6.1 **37-47 THISTLETHWAITE STREET, SOUTH MELBOURNE**
LOCATION/ADDRESS: **37-47 THISTLETHWAITE STREET, SOUTH MELBOURNE**
EXECUTIVE MEMBER: **LILI ROSIC, ACTING GENERAL MANAGER, PLACE STRATEGY AND DEVELOPMENT**
PREPARED BY: **ROSANNE MASSEY, SENIOR URBAN PLANNER**
DONNA D'ALESSANDRO, PLANNING COORDINATOR
GATEWAY WARD

1.1 To consider and determine application P0475/2017 for the demolition of the existing buildings and construct an eight storey (including a five storey podium) mixed use (Retail, Office, and Accommodation; including dwellings) building and associated car and bicycle parking and construct and/or carry out works in the Capital City Zone (CCZ1). Use land for Accommodation (Dwelling) in the CCZ1. Construct a building and construct and/or carry out works in the Design and Development Overlay (DDO30) and Special Building Overlay (SBO2).

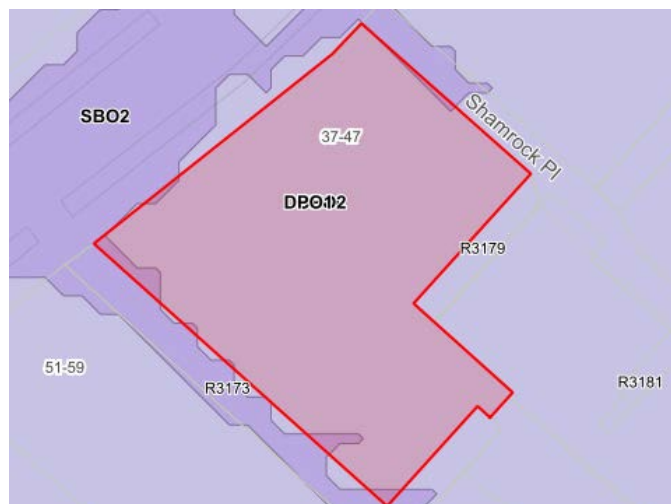
11.11.1 The site is partially affected by the Special Building Overlay Schedule 2. Council is the Relevant Authority for the overlay as it relates to the Port Phillip City Local Drain. The below image details the extent of the SBO2 in purple, the subject site is outlined in red.

11.11.2 In accordance with Council's Development Engineer's comments it is considered that the FFL of the south-west 150m² office/retail space should be a minimum of 2.717m AHD as it is located within the SBO2 and is non-habitable (currently shown as 2.4RL). The FFL of the Car Park within the south-west section of the site should be no more less than 2.567m AHD (currently shown as 2.4RL).
